SUBJECT: VILLAGE OF HOFFMAN ESTATES
2025 STORM SEWER REHABILITATION
CLARIFICATIONS AND RESPONSE TO QUESTIONS #2

This letter is meant to clarify additional questions and concerns regarding the 2025 Storm Sewer Rehabilitation Project. This is not considered an addendum, but an additional resource for your information and consideration.

STORM SEWER OUTLET CHAMBER

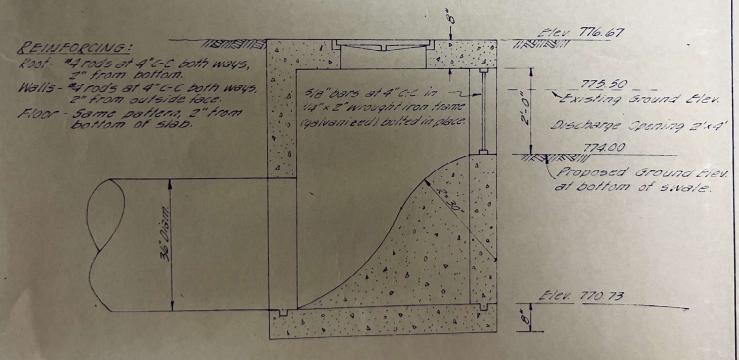
- 1. There are some pipe outlets that are partially or completely under lake water levels. This level varies depending on time of year and storm runoff events. It will be the responsibility of the contractor to locate the inverts of these pipes. This work is covered under the 'Dewatering' pay item.
- 2. The use of pumps to lower water levels in ponds, pipes, and structures is allowed and covered under the 'Dewatering' pay item.
- 3. FES-0454 is an outfall structure at the North end of Larchmont Road. The pipe to be lined connects to this outlet below ground elevation as shown in the attached detail.
